# UNITED STATES PATENT AND TRADEMARK OFFICE

APPLICATION NO.	FILING DATE	FIRST NAMED INVENTOR	ATTORNEY DOCKET NO.	CONFIRMATION NO.
10/764,997	01/26/2004	Thomas Farkas	1465.2009-003	6767
21005	7590	05/06/2005		
HAMILTON, BROOK, SMITH & REYNOLDS, P.C. 530 VIRGINIA ROAD P.O. BOX 9133 CONCORD, MA 01742-9133			EXAMINER ENGLUND, TERRY LEE	
			ART UNIT	PAPER NUMBER
			2816

**Office Action Summary**

Appl'n No.: 10/764,997  
Title: CHARGE PUMP BYPASS  
Inventors: Thomas Farkas, *et al.*  
Replacement Sheet

**FIG. 1**

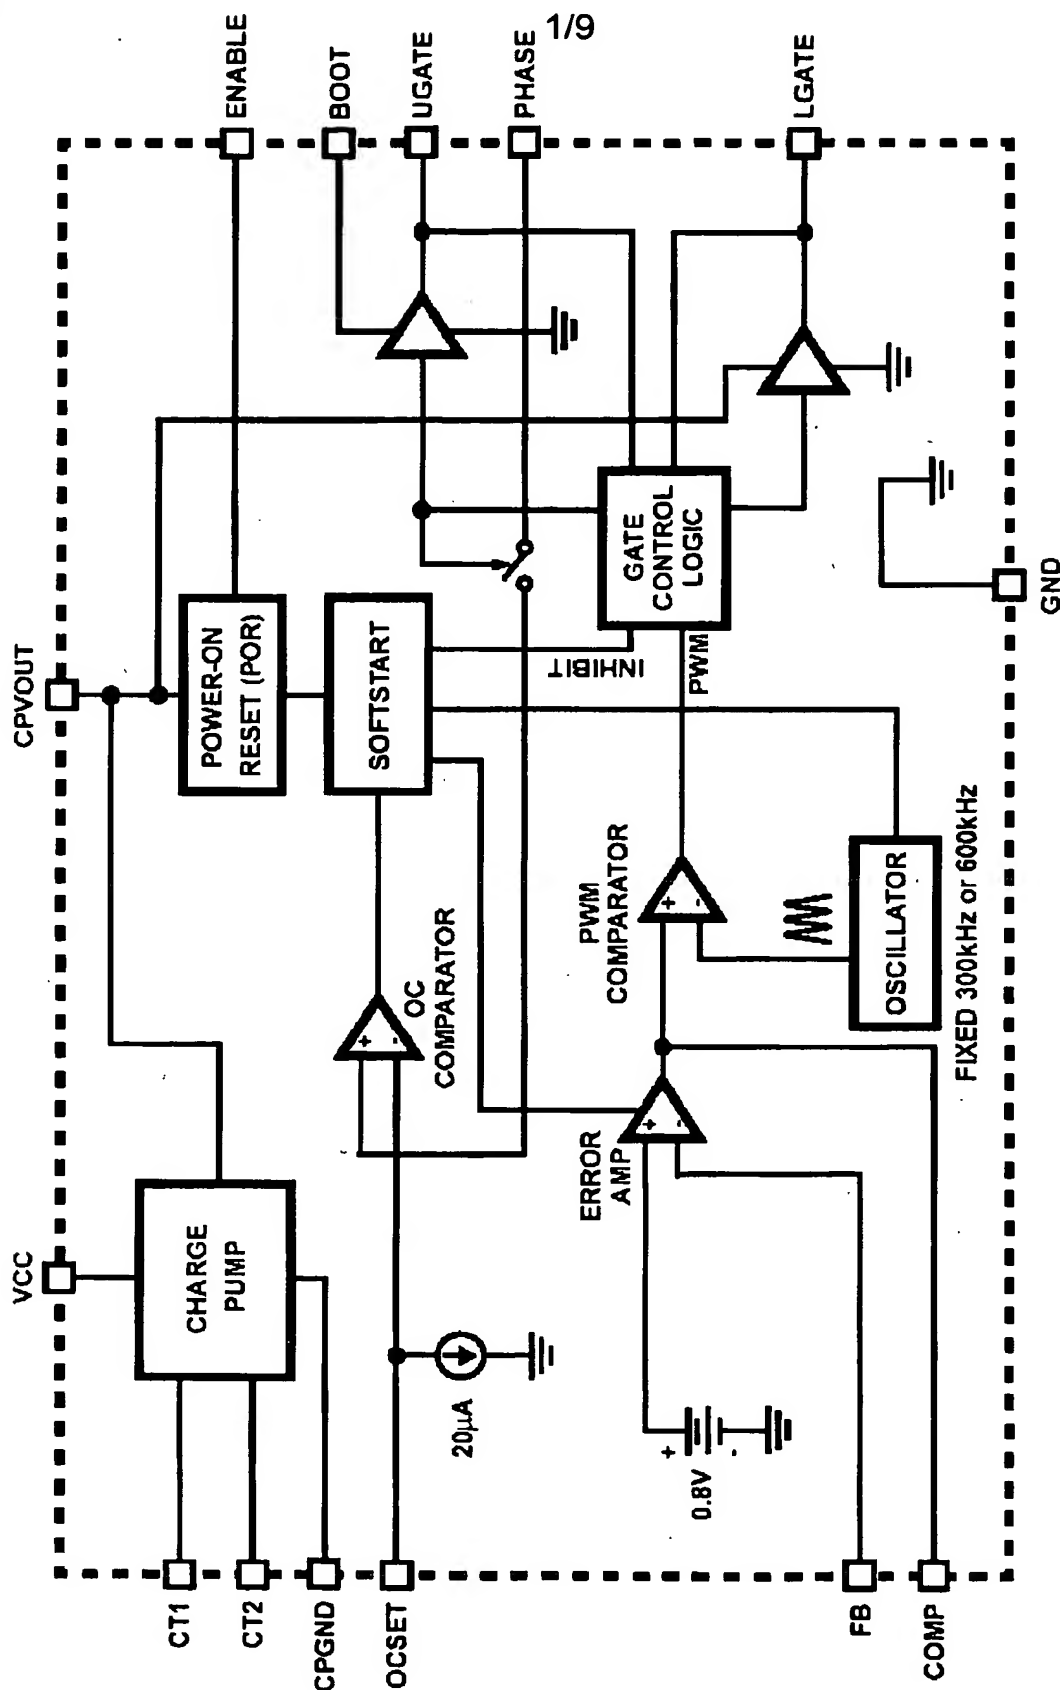
It is believed Figs. 1–3b should be designated by a legend such as --Prior Art-- because only that which is old is apparently illustrated. For example, page 1, lines 16-17 identify Intersil ISL6526 (shown in Fig. 1, as described on pages 3 (line 15) and 4 (line 6) within the Background of the Invention; Fig. 2 shows “a standard 4-switch charge pump” (e.g. see page 4, lines 18-19); Fig. 3a shows “a typical implementation of a Synchronous Buck DCDC Converter” (e.g. see page 4, lines 25-26); and Fig. 3b shows a variation of Fig. 3a, wherein it is used for “ $V_{cc} > 4.5$  V. Obviously, the manufacturer did not foresee the desirability of using this PWM IC” (e.g. see page 5, lines 11-14), implying the circuit structure is known with respect to its use with 3.3V and 5V input voltages. See MPEP § 608.02(g). Corrected drawings in compliance with 37 CFR 1.121(d) are required in reply to the Office action to avoid abandonment of the application. The replacement sheet(s) should be labeled “Replacement Sheet” in the page header (as per 37 CFR 1.84(c)) so as not to obstruct any portion of the drawing figures. If the changes are not accepted by the examiner, the applicants will be notified and informed of any required corrective action in the next Office action. The objection to the drawings will not be held in abeyance.

The drawings are objected to as failing to comply with 37 CFR 1.84(p)(5) because they include the following reference character(s) not mentioned in the description: At least CT1, CT2, CPGND, OCSET, FB, COMP, ENABLE, BOOT, PHASE,  $C_{IN}$ ,  $C_{PUMP}$ ,  $C_1$ ,  $R_F$ ,  $C_F$ ,  $R_{OFFSET}$ ,  $R_{FB}$ ,  $D_{BOOT}$ ,  $C_{BOOT}$ ,  $C_{DCPL}$ ,  $R_{OCSET}$ ,  $C_{BULK}$ , and  $C_{HF}$  are shown in each of Figs. 3a-4, with many of them also shown in Fig 1. However, why are none of these mentioned, or described, in the disclosure? R1 of Figs. 6, 7 and 9 is not mentioned within their respective descriptions.

Replacement  
Engs: 1-15  
NOT APPROVED  
4.20.05  
TLE

Corrected drawing sheets in compliance with 37 CFR 1.121(d), or amendment to the specification to add the reference character(s) in the description in compliance with 37 CFR 1.121(b) are required in reply to the Office action to avoid abandonment of the application. Any amended replacement drawing sheet should include all of the figures appearing on the immediate prior version of the sheet, even if only one figure is being amended. Each drawing sheet submitted after the filing date of an application must be labeled in the top margin as either "Replacement Sheet" or "New Sheet" pursuant to 37 CFR 1.121(d). If the changes are not accepted by the examiner, the applicant will be notified and informed of any required corrective action in the next Office action. The objection to the drawings will not be held in abeyance.
